PRAIRIE ISLAND NUCLEAR GENERATING PLANT UNIT 1

AMENDMENT TO FACILITY OPERATING LICENSE

Amendment No., 13
License No. DPR-42

SUPPORTING AMENDMENT NOS. 13 AND 7 TO
FACILITY OPERATING LICENSE NOS. DPR-42 AND DPR-60

FIGURE 6.1-1

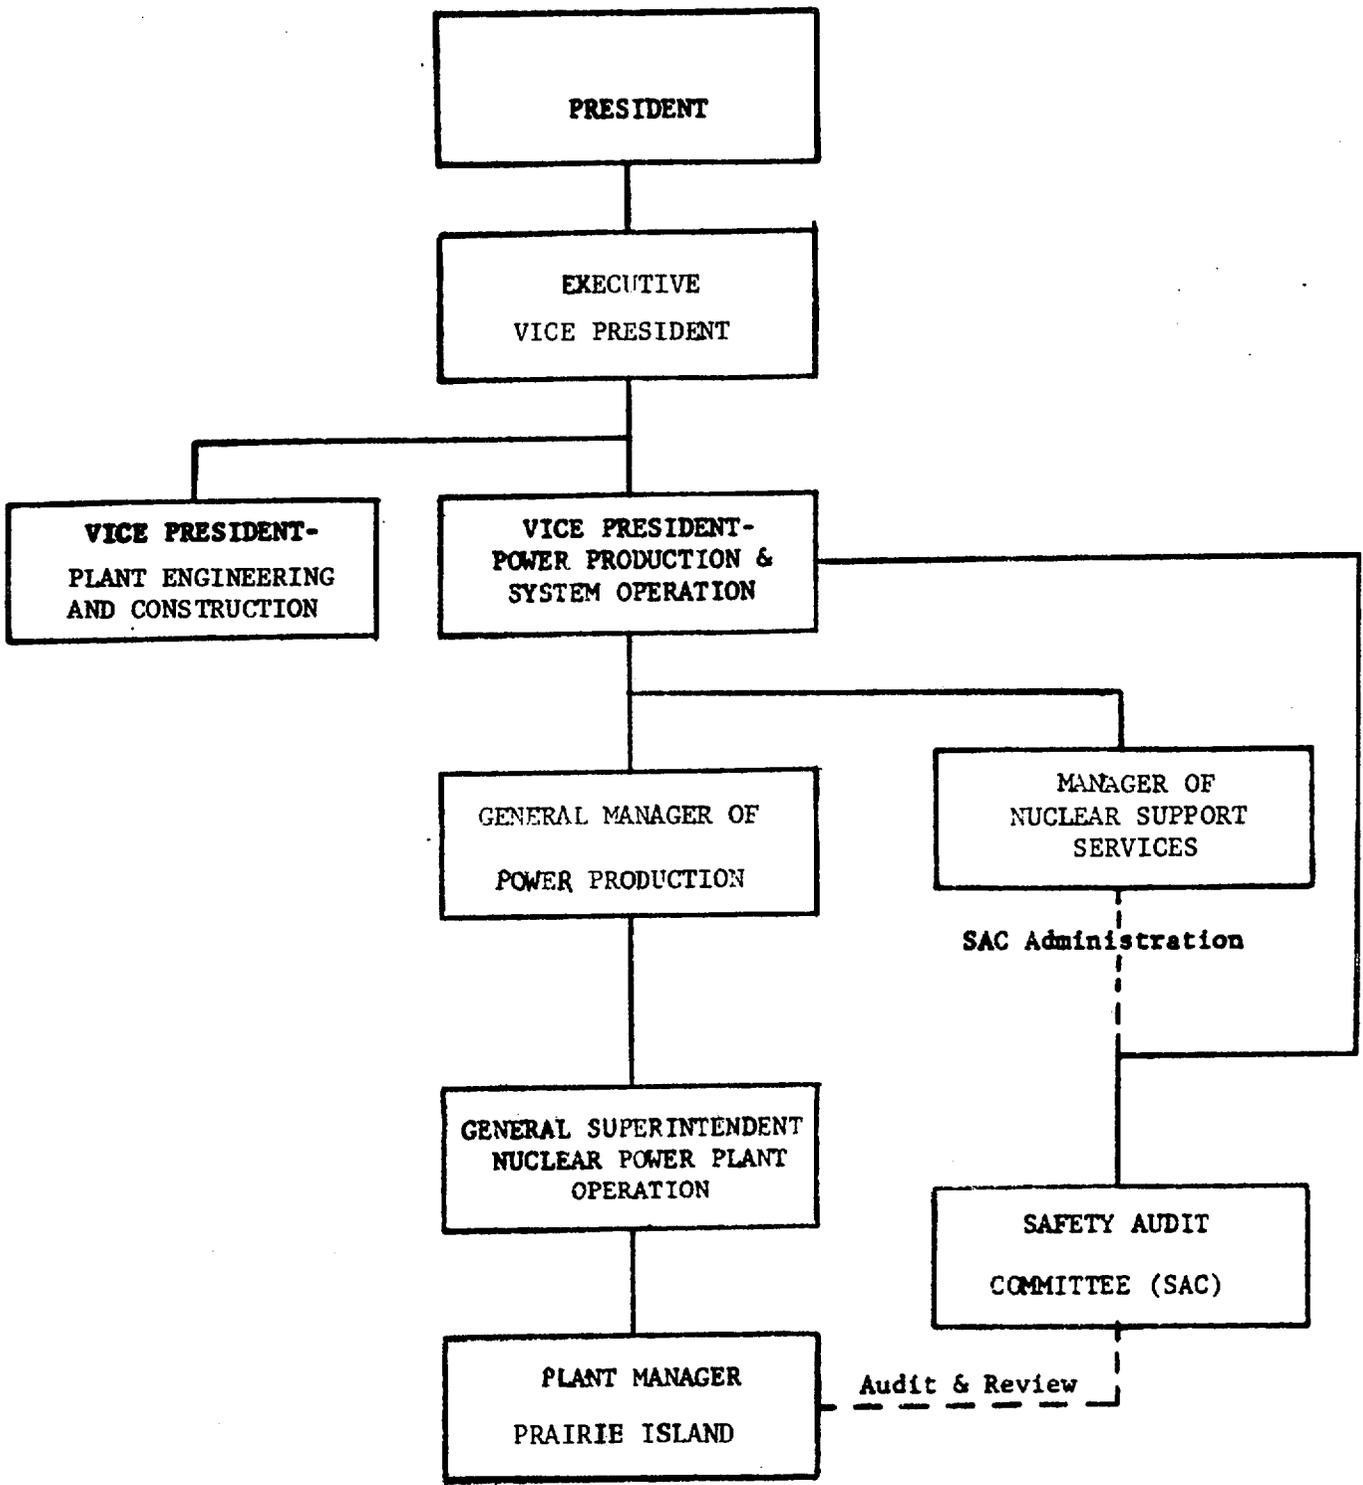
The change to the Prairie Island Nuclear Generating Plant Units 1 and 2 Organization would consist of the addition of the position of Training Supervisor, who will report to the Superintendent - Operation and Maintenance. The Training Supervisor is responsible for conducting the Prairie Island Operator Requalification Program. We have concluded that the addition of this position will strengthen the organization and therefore is satisfactory.

1. The replacement of the Group Vice-President - Power Supply by the Executive Vice-President. The original NSP Organization included three Group Vice-Presidents. In an effort to consolidate and provide

more effective functional division of organization responsibilities, two Executive Vice-Presidents, one for internal operations and one for external operations, were named to replace the three Group Vice-Presidents. The Executive Vice-President for Internal Operations is the officer depicted on Figure 6.1-1. We have concluded that such consolidation of the organization will not weaken the effectiveness of the organization with respect to nuclear safety and is therefore acceptable.

2. The title of Vice-President - Engineering has been changed to Vice-President - Plant Engineering and Construction to more accurately reflect his responsibilities within the new organization. The original position of Vice-President - Engineering included all engineering and construction functions. This change confines the engineering and construction responsibilities of the position to plant-oriented tasks. Responsibility for transmission lines and substations have been transferred to another position. We have concluded that this delineation of responsibility as reflected in the title change is acceptable.

3. The title Director of Nuclear Support Services has been changed to that of Manager of Nuclear Support Services. The lines of communication have been altered such that the Manager of Nuclear Support Services and the Safety Audit Committee now report directly to the Vice-President - Power Production and System Operation rather than the Executive Vice-President (formerly Group Vice-President).

The change in position title from Director to Manager of Nuclear Support Services is only a change in title and carries no change in responsibilities. The changes in lines of communication for the Manager of Nuclear Support Services and Safety Audit Committee reflect NSP's desires to consolidate the organization in such a manner that the Vice-President - Power Production and System Operation shall maintain direct cognizance of all nuclear and fossil activities. The NRC staff feels that this strengthens the NSP organization by providing direct communication to one individual who is responsible for all nuclear matters, thus effectively shortening the chain of command. The change is therefore acceptable.

4. The former title Manager of Power Production has been changed to General Manager of Power Production. The responsibilities of this position include management of operation and maintenance for all fossil and nuclear generating plants. The NRC staff has concluded that the change of title to more accurately reflect the amount of responsibility is acceptable.
